STAFF RECOMMENDATION
4100 Aberdeen Road
October 21, 2020

Application: New Construction—Infill
District: Cherokee Park Neighborhood Conservation Zoning Overlay
Council District: 24
Base Zoning: R8
Map and Parcel Number: 10308019200
Applicant: Van Pond, Architect
Project Lead: Sean Alexander, sean.alexander@nashville.gov

Description of Project: The proposal is to construct a one and-one-half story house with an attached garage, replacing a non-contributing one-story house. The new house will have brick walls on the first story and half-timbering and panel cladding on the upperstory gable fields.

1 PROPOSED SITE PLAN

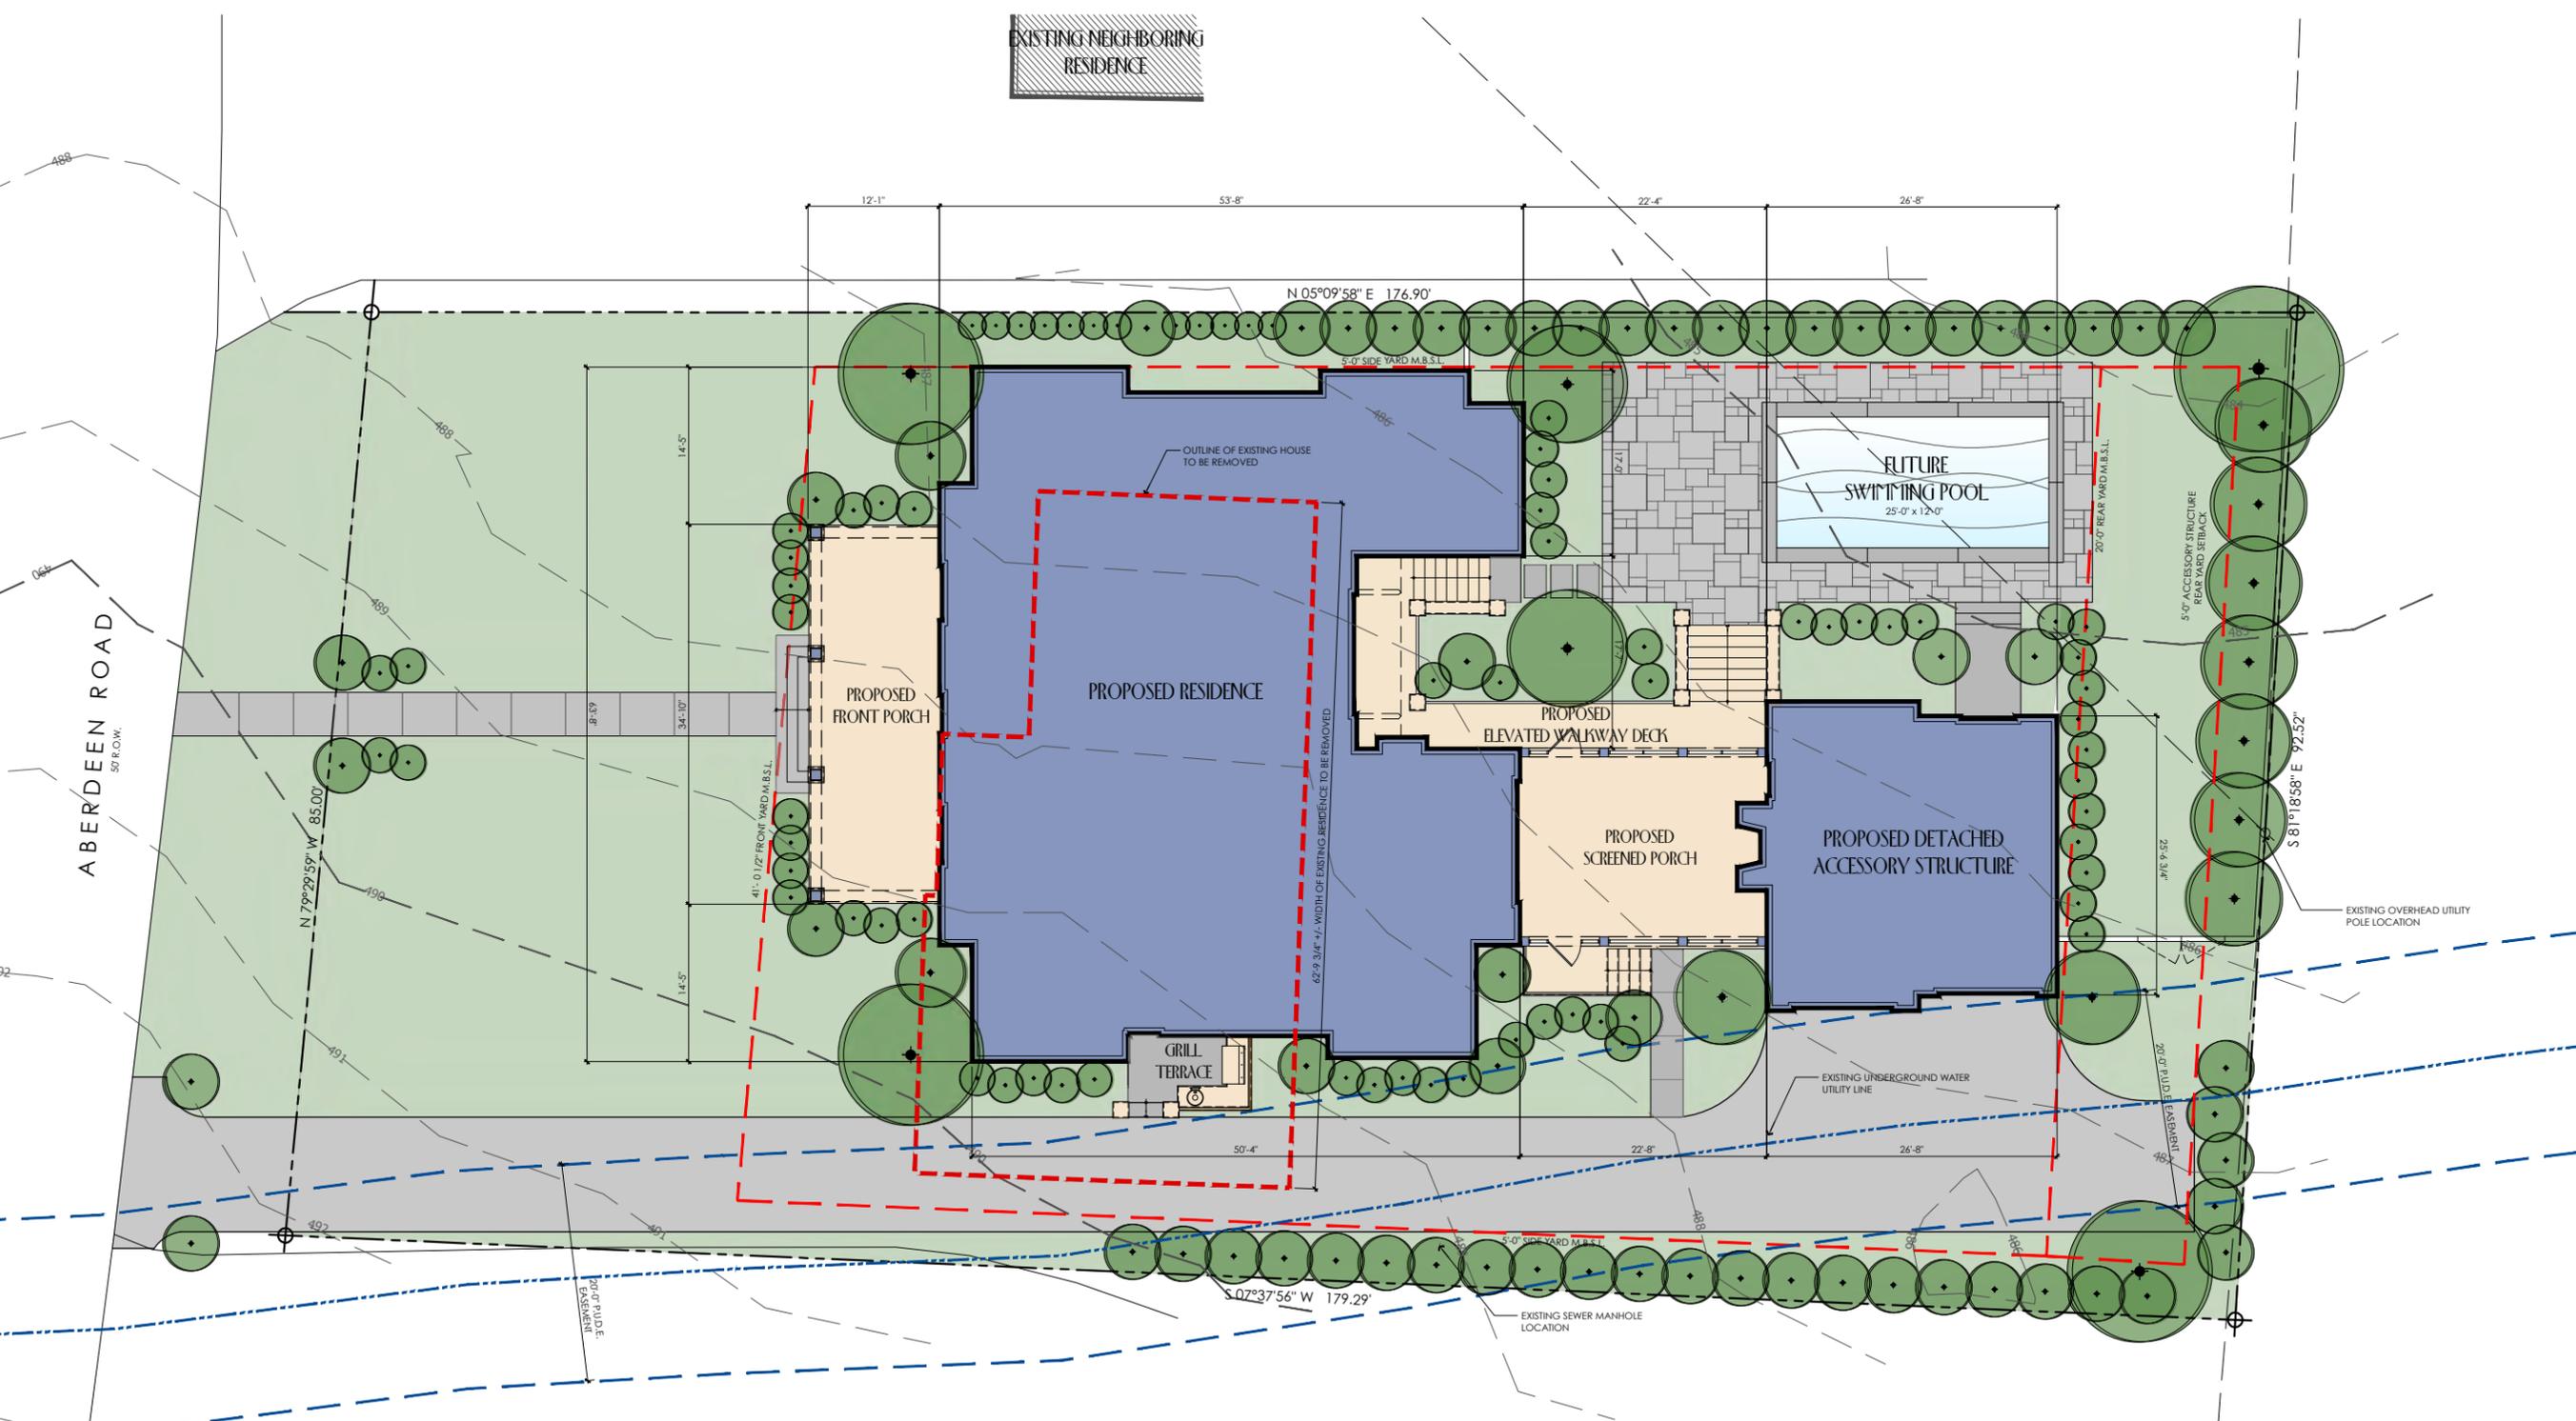
The proposed infill at 4100 Aberdeen Road will be sixty-three feet, nine inches (63'-9") wide in total which is wider than both adjacent houses. The house to the right is fifty-seven feet (57') wide and the house to the left, which is currently the widest house in the immediate vicinity, is sixty-one feet (61') wide. The houses to the right and left are also located on wider lots, one hundred feet (100') and one hundred, twenty feet (120') respectively, whereas this lot is eighty-five feet (85') wide. Staff finds that the width of the proposed building is not appropriate and recommends that the width shall be limited to fifty-six feet (56') to be compatible with the surrounding context on similarly sized lots.

Setback & Rhythm of Spacing: The infill is proposed to be located with its front wall in line between the fronts of the two adjacent historic houses. The house will be shifted toward the left side of the lot to accommodate a driveway on the right side and will have side setbacks of five feet (5') on the left side and eighteen feet (18') on the right. The spacing between the proposed

house and the historic house to the left will appear greater, however, because the house to the left is on a double lot with an atypically wide side yard. Historic houses in the Cherokee Park neighborhood are typically shifted to one side to accommodate side yard driveways because the lots do not have alleys at the rear, therefore staff finds that these setbacks are consistent with those of surrounding historic houses nearby.

Appurtenances & Utilities: The location of the HVAC and other utilities is not indicated on the submitted site plan. Staff asks that the HVAC be located on the rear façade, or on a side façade beyond the midpoint of the house.

1. The width of the house shall be reduced to fifty-six feet (56');
2. The foundation material shall be different from that of the primary wall material;
3. All materials shall receive final approval from staff prior to purchase and installation: foundation material, window and door selections, roof colors; driveway and walkway; and,
4. The HVAC units shall be behind the midpoint of the building.

1 PROPOSED MAIN FLOOR PLAN

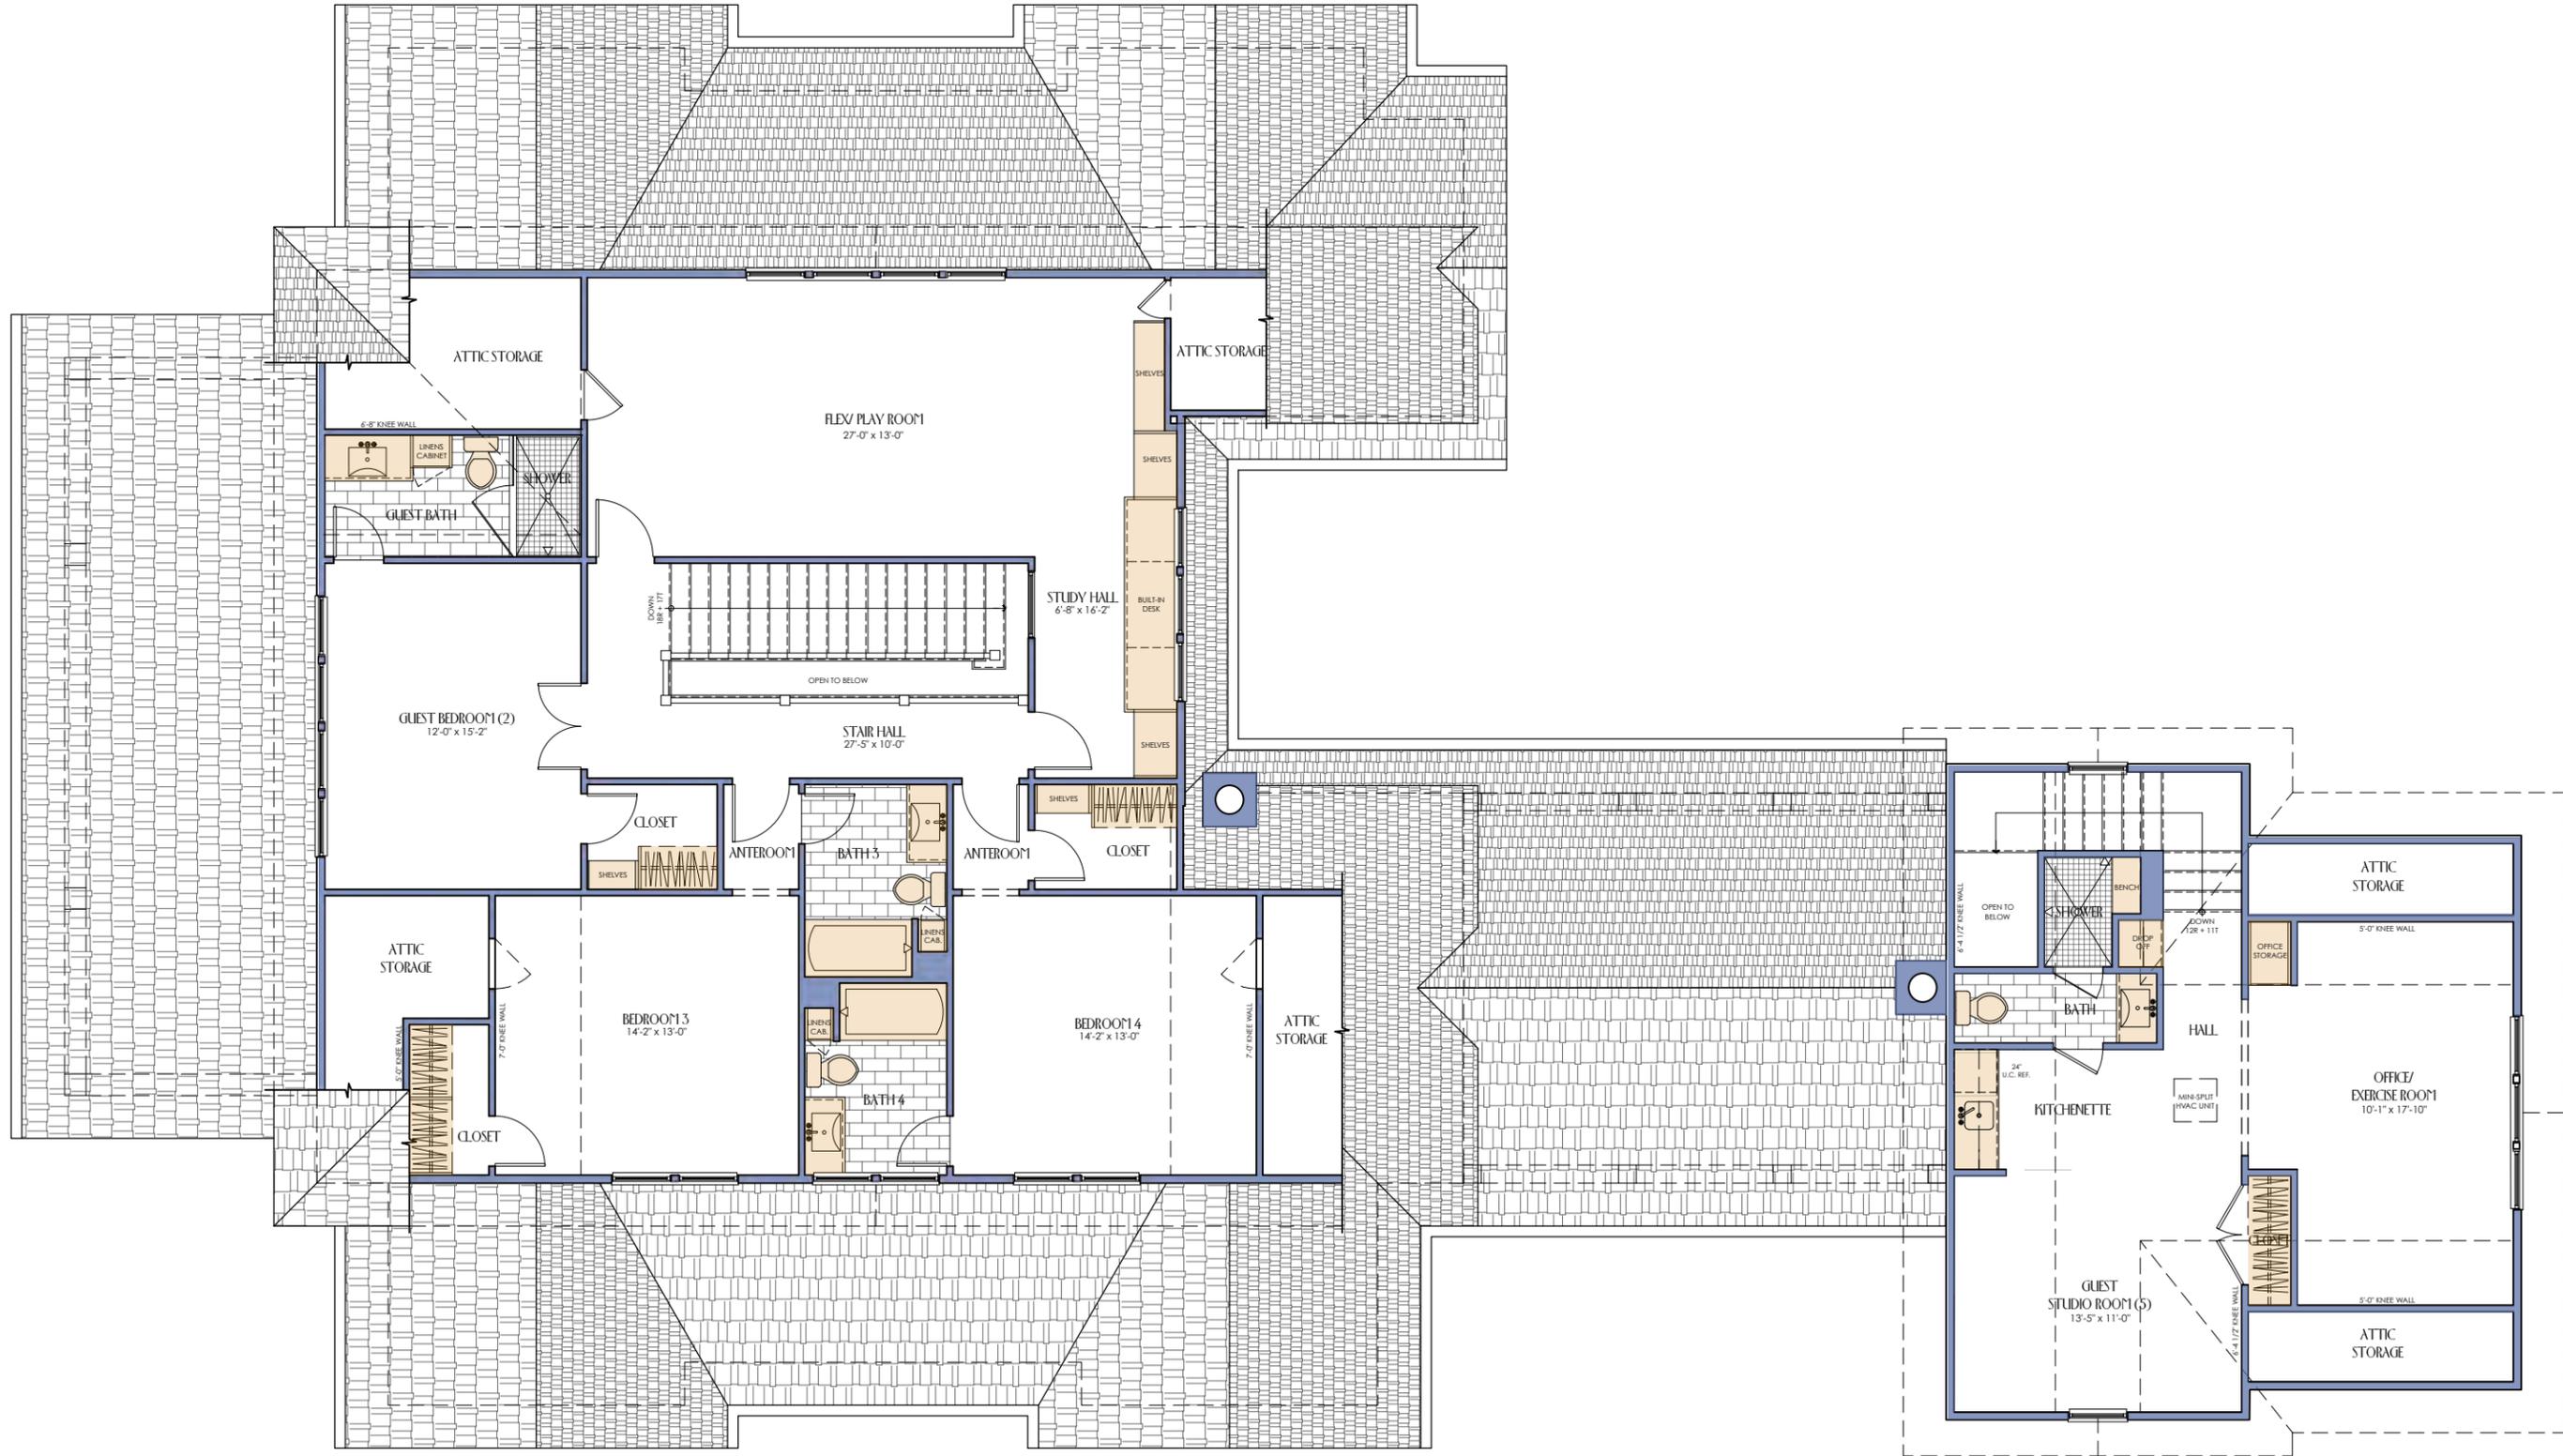
The primary massing of the building will extend fifty-three feet (53') from front to back, followed by a twenty-two foot (22') deep screened porch and a twenty-seven foot (27') deep garage at the very rear. The total depth of one hundred, two feet (102') is considerably greater than is typical of historic houses in the immediate vicinity; however, the house includes an attached garage, which adds to the total length. An attached garage is appropriate in this instance because of the lack of rear alley and because the garage is located in a typical location for garages in this neighborhood. In addition, the connector between the house and garage is a single story and is stepped in from the side so as to be minimally visible.

PROPOSED FRONT
 ELEVATION

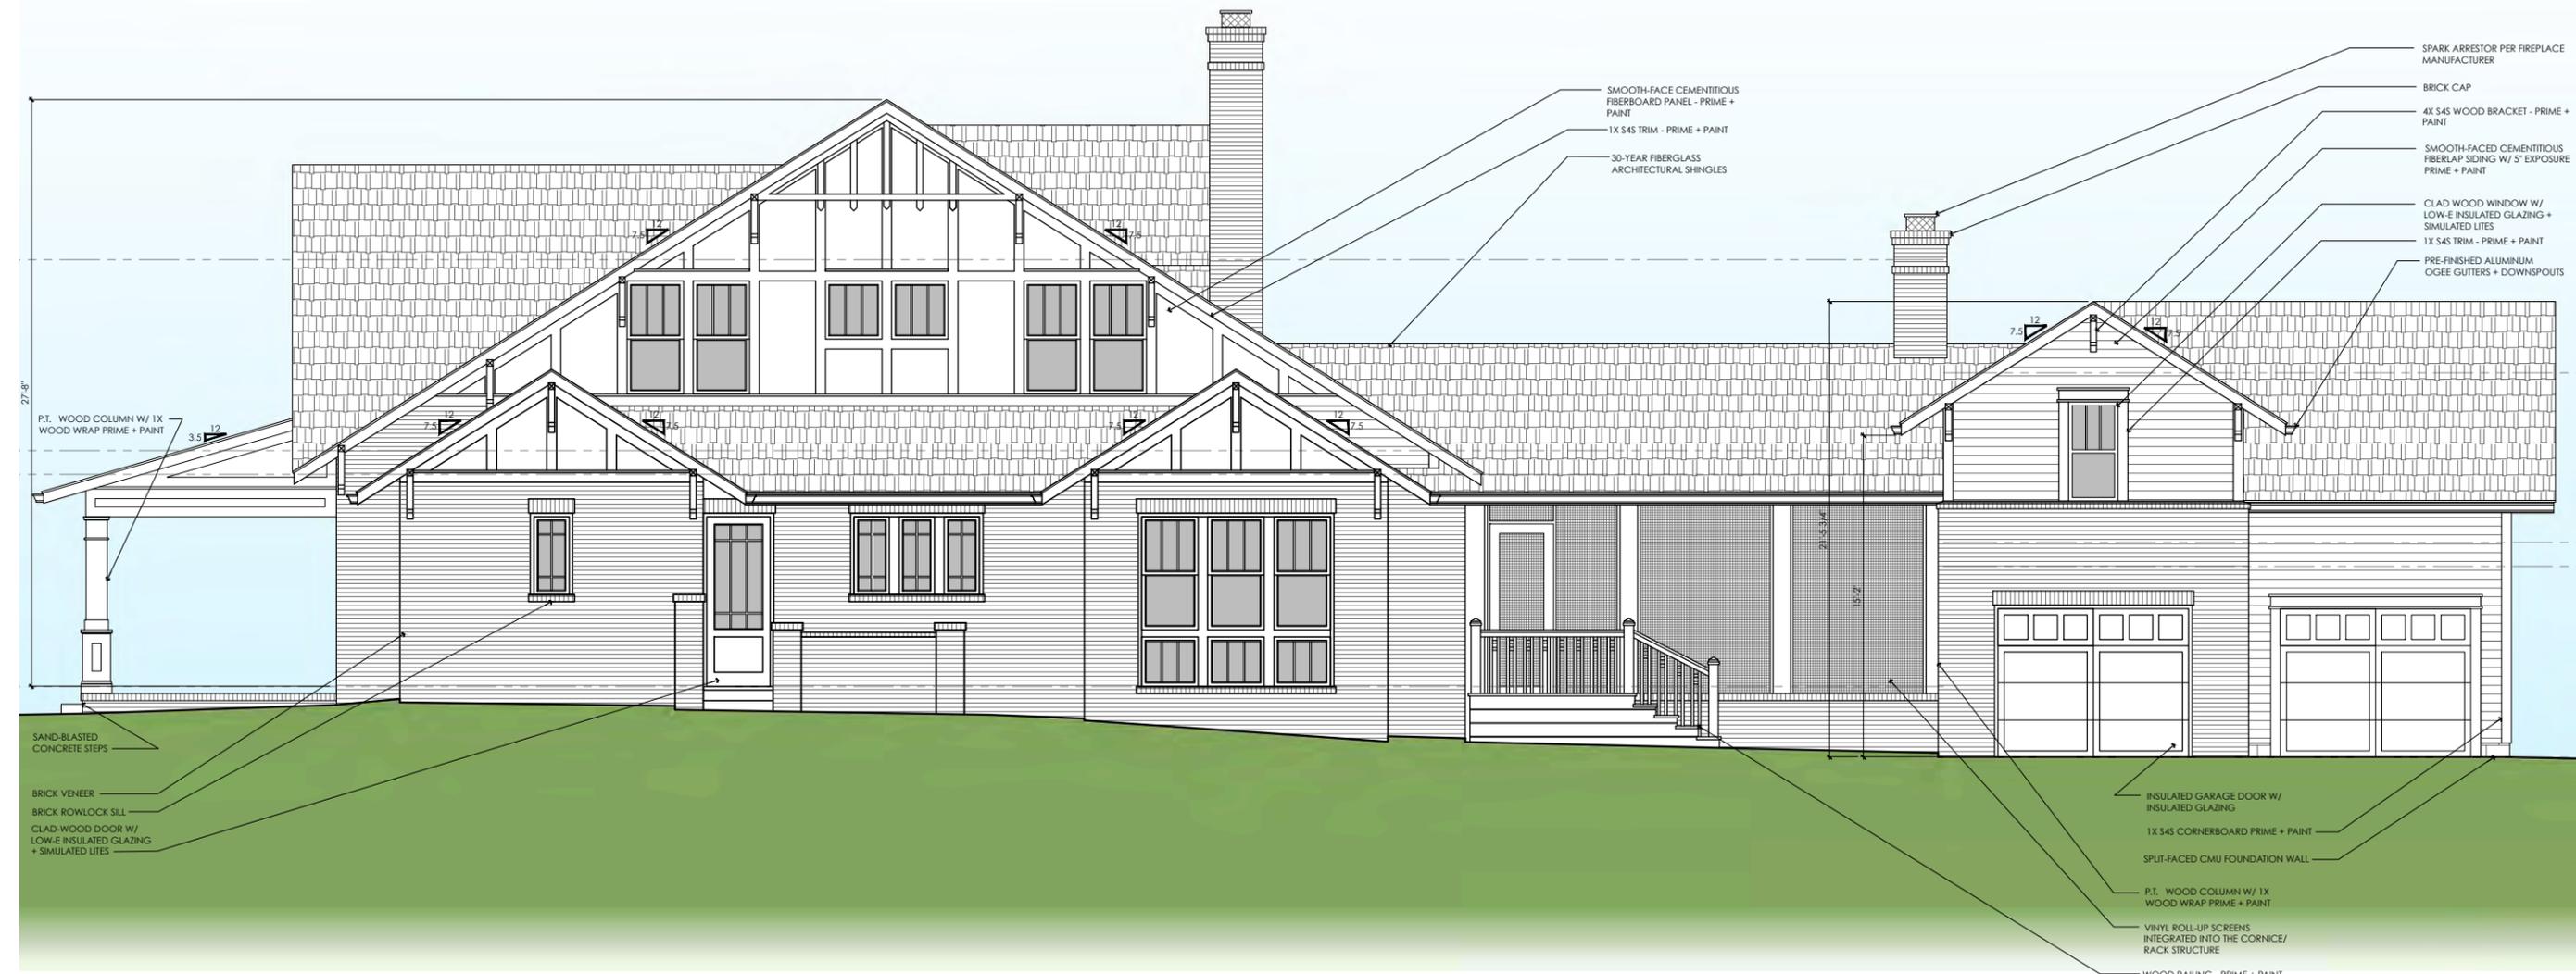
The primary wall and foundation material would both be brick, whereas houses in the neighborhood typically have a differing foundation and wall materials. Staff finds the height of the house’s roof and eaves to be appropriate, but that the continuous brick from eave to grade exaggerates the appearance of the primary wall height.

Orientation: The new house will be oriented with the primary entrance facing the street, with a projecting front porch comprising the majority of the building’s primary center component. The porch will be thirty-six feet (36’) wide and twelve feet (12’) deep. The house will be shifted toward the left side of the lot with a driveway running along the right side of the house, with a walkway connecting the front porch to the street in front. This orientation is similar to several surrounding houses along Aberdeen Road.

Proportion and Rhythm of Openings: The windows on the front and side of the proposed infill are all generally twice as tall as they are wide, thereby meeting the historic proportions of openings. There are no large expanses of wall space without a window or door opening.

As a condition of approval, staff recommends that the foundation material shall be different from that of the primary wall material, and that the applicant seek final approval of masonry, fiber-cement texture, roof colors, window and door selections, and paving materials.
